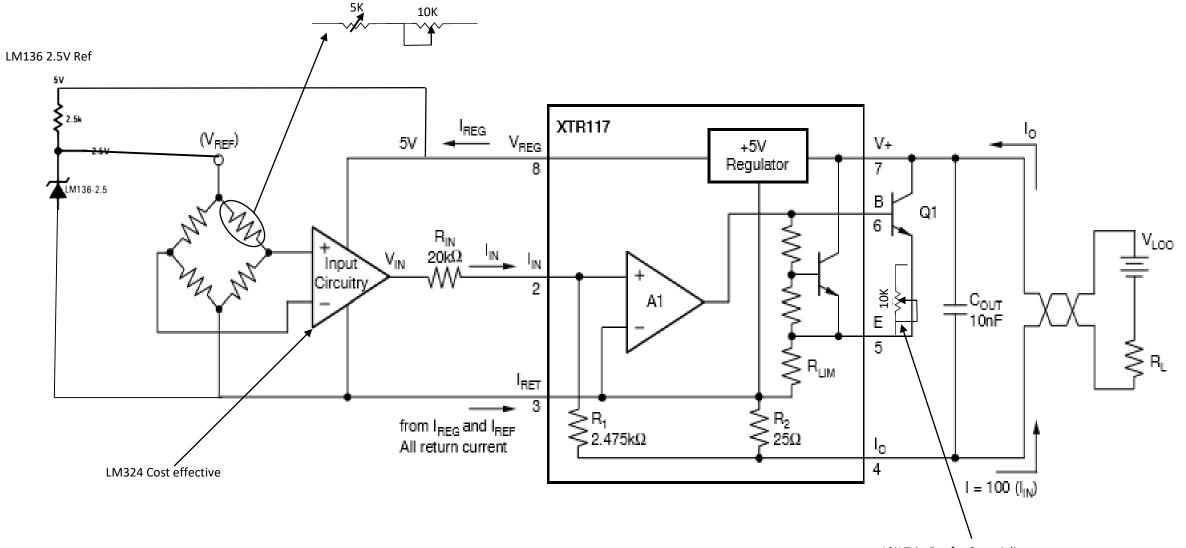
Replaced with 5K Pot attached with valve and a series trim pot value 10K for Zero adjustment

10K TrimPot for Span Adjustment
